Service Bulletin

Bulletin Number: **SB-18-302**
Release Date: **October 12, 2018**
Subject: **Rear Mounting Pin Weldment Replacement**
Distribution: **Affected Heil Dealers, Customer Service, Field Service**

Figure 1. Rear Mounting Pin Weldment Repair Installations (372-8847 and 372-8848)

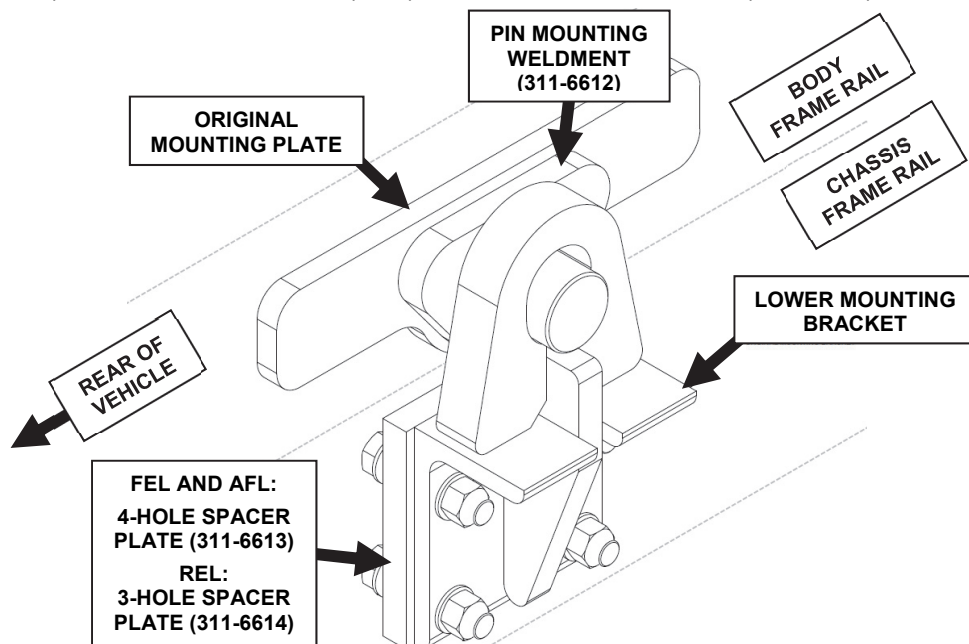
With the unit prepared as described in Paragraph 2 of this Service Bulletin, in **Lock-Out/Tag-Out mode**, carefully follow the steps below for **each side of the unit**. Use the appropriate kit from **Table 3**. Typically, Front End Loader (FEL) and Automated Side Loader (ASL) units use 4-Hole Mount Kit (372-8847) while Rear End Loader (REL) units use 3-Hole Mount Kit (372-8848). See **Figure 1**.

Figure 2. Lower Mounting Bracket Removed and Upper Mounting Weldment with Pin Removed

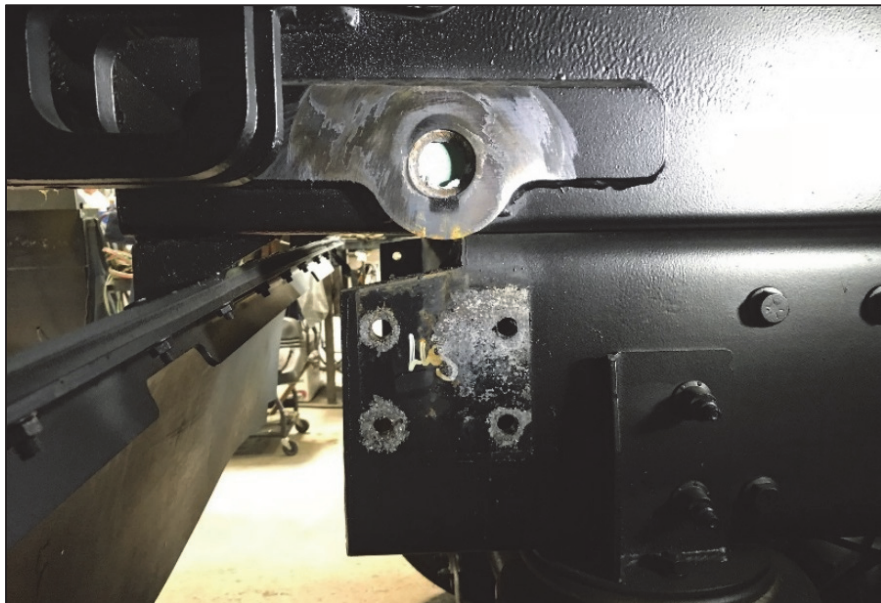
- (1) Remove the Lower Mounting Bracket that is bolted to the chassis frame rail. Save this for reuse later. Discard fasteners: the bolts, washers and nuts must be replaced.
- (2) The pin in the upper mounting weldment must be removed. Hit the pin with a 5 lb sledge hammer in an alternating horizontal direction to dislodge and remove it. Discard the pin. Then grind the surface of the original mounting plate.

NOTE: If the pin remains, cut the pin utilizing an oxyacetylene torch and grind flush with the mounting plate. Utilize protective equipment to ensure no chassis or body components are damaged during the cutting process. Make sure an A, B, C rated fire extinguisher is present during all times while using the torch. See **Figure 2**.
